Project	IEEE 802.16 Broadband Wireless Access Working Group < http://ieee802.org/16 >	
Title	The Enhancement of the MAC Management Messages for the NSP Discovery	
Date Submitted	2005-07-21	
Source(s)	Duke Dang, Phillip Barber, Lucy Chen, David Xiang, John Lee HUAWEI Jose P. Puthenkulam Intel	Voice: 86-10-82882959 Fax: 86-10-82882966 mailto:dsjun@huawei.com
Re:	Call for contribution and comments.	
Abstract	The Enhancement of the MAC Management Messages for the NSP Discovery.	
Purpose	Adoption	
Notice	This document has been prepared to assist IEEE 802.16. It is offered as a basis for discussion and is not binding on the contributing individual(s) or organization(s). The material in this document is subject to change in form and content after further study. The contributor(s) reserve(s) the right to add, amend or withdraw material contained herein.	
Release	The contributor grants a free, irrevocable license to the IEEE to incorporate material contained in this contribution, and any modifications thereof, in the creation of an IEEE Standards publication; to copyright in the IEEE's name any IEEE Standards publication even though it may include portions of this contribution; and at the I

Figure 1 – A coverage area with overlapping ASNs

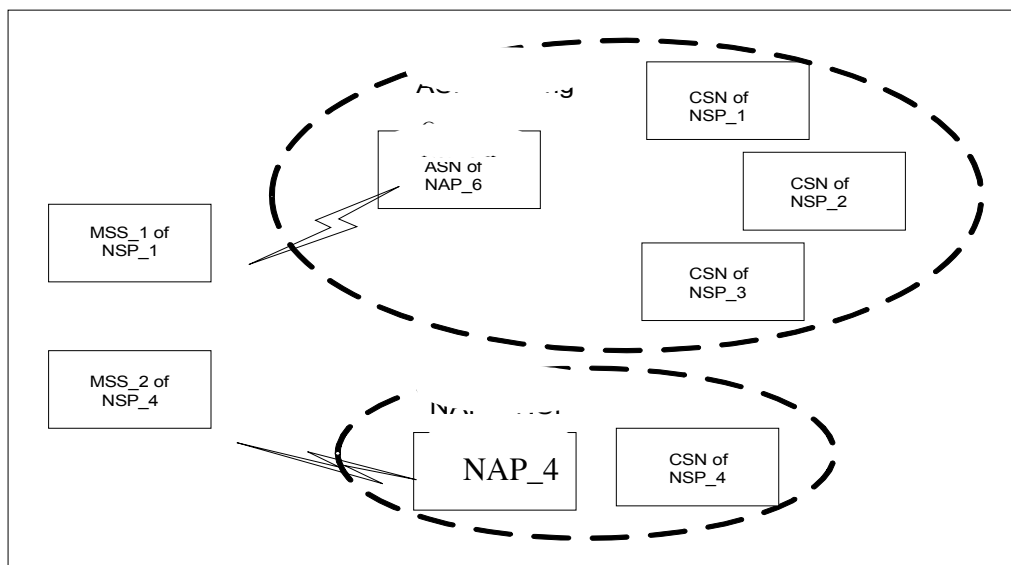
For example, as shown in Figure 1, MSS_1 and MSS_2 discover available NSPs and select one based on its configuration information. More specifically, MSS_1 prefers to connect to Operator Network of “NAP_6” because it is directly affiliated with MSS_1’s home NSP through Operator Network sharing. And, MSS_2 prefers to connect to Operator Network of “NAP_4” because it is owned by MSS_2’s home NSP (i.e., NSP_4).
